ROAD SAFETY AUDIT

Title: STAGE 1 ROAD SAFETY AUDIT

Office Innovation Campus, Moygaddy, Co. Meath.

Report reference: 1388R01

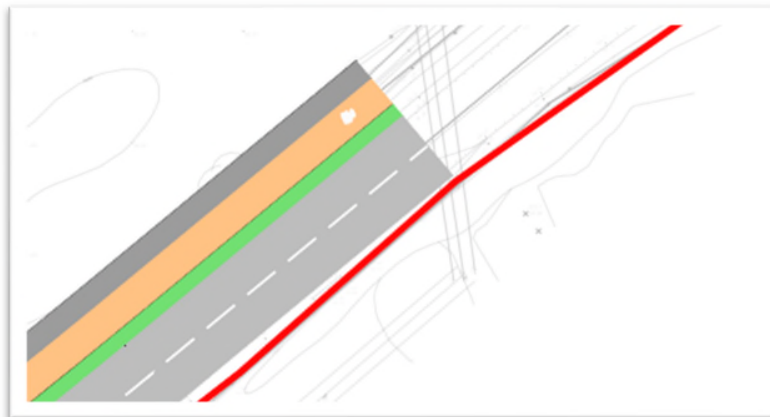
General Comment tie-in points

Details have not been provided of how the cycle track and footpaths will tie in at the scheme extents. Cyclists and pedestrians will have to cross the carriageway to access the facilities. Without suitable transitions from off road to on road and suitable crossing facilities there is a risk that pedestrians and cyclists will be struck by passing traffic.

It is recommended that suitable transitions and crossing facilities be provided.

3.1	Y	Y	The proposed cycle lane along the R157 eastern arm will be updated to tie into the carriageway. A suitable Jug turn will be provided on the opposite side of the road to accommodate the cyclists' right turning movement towards the development	Yes

Drawing S665- OCSC-1A-MH-DR-C-0111 S2 P01 Sheet 2 of 3, cycle track across campus access road.

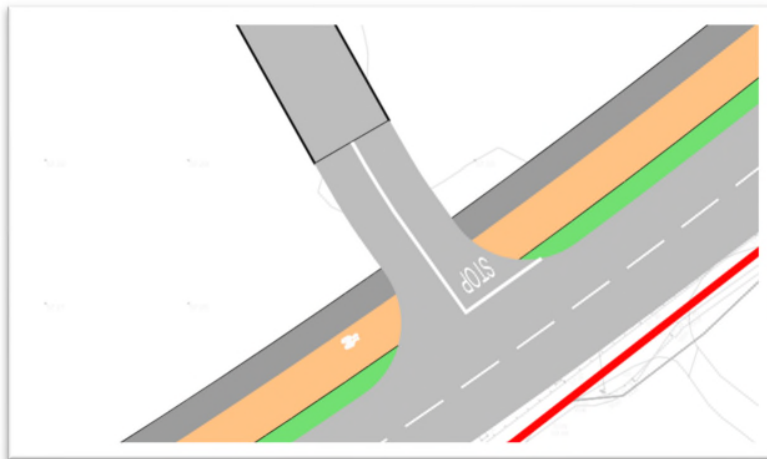
The proposed two way cycle track crosses the mouth of the campus access road. There is a risk that drivers exiting the campus may not expect two way cyclists as they approach the stop line.

It is recommended that a 'bend out crossing' be provided.

3.2	Y	N	It is proposed to provide a shared space and tactile for crossing before the cyclist and pedestrians approach the junction. A raised crossing will be provided to indicate priority for pedestrians and cyclists.	Yes

Drawing S665- OCSC-1A-MH-DR-C-0111 S2 P01 Sheet 2 of 3, campus access road.

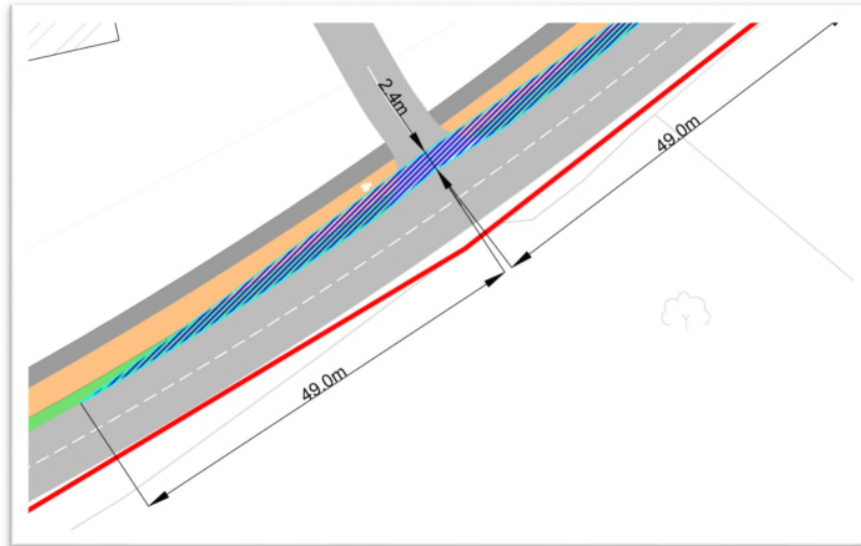
There is a signalised pedestrian crossing of the R157 eastern section, however there is no footpath on that side. This could lead to slips and falls if pedestrians cross into the grassed verge.

It is recommended that a section of footpath be provided linking the north-south and east west pedestrian crossing areas. The crossing should be retained to be able to cater for potential future development.

3.3	Y	Y	A shared facility has been provided within the campus at required widths which ties into the external pedestrian and cyclist network.	Yes
3.4	Y	N	There are insufficient spaces to provide walkways and cycle lanes along the south-eastern parts of the design (boundary wall). As such, two way movements will take place on the opposite sides. Pedestrian crossing lines have been removed from the junction on the eastern and southern legs.	Yes

Drawing S665- OCSC-1A-MH-DR-C-0111 S2 P01 Sheet 2 of 3, Carton Estate boundary wall.

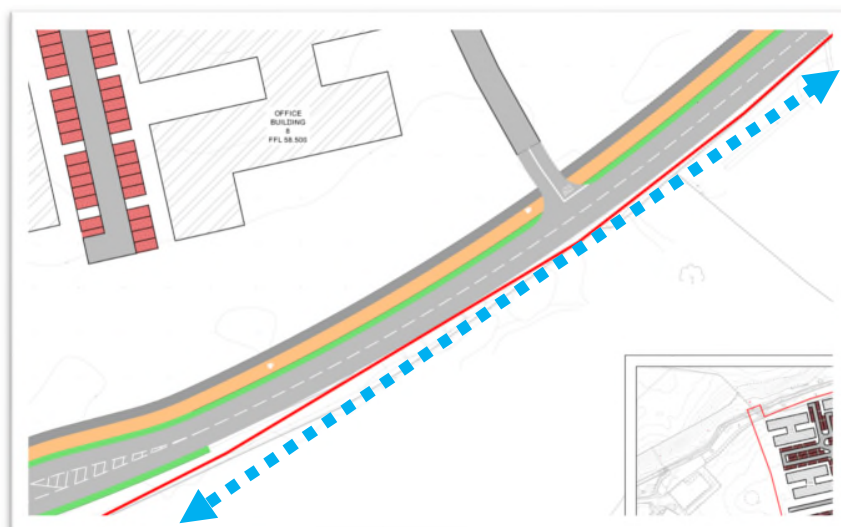
The realigned R157 eastern arm is very close to the stone wall of the Carton Estate. This is a hazard for an errant vehicle.

It is recommended that a suitable Clear Zone be provided between the boundary wall and the realigned carriageway.

distributor road and development is completed	
3.6	Y	Y	It is proposed to utilize the existing R157 road alignment as an off-road trail truck. The gate can be accessed via this trail in future once the development is completed.	Yes
3.7	Y	N	The proposed 1.5m verge separation is an improvement to the existing condition. As the section of road is fairly straight and the speed is being reduced, it is not anticipated that this would be a problem.	Yes
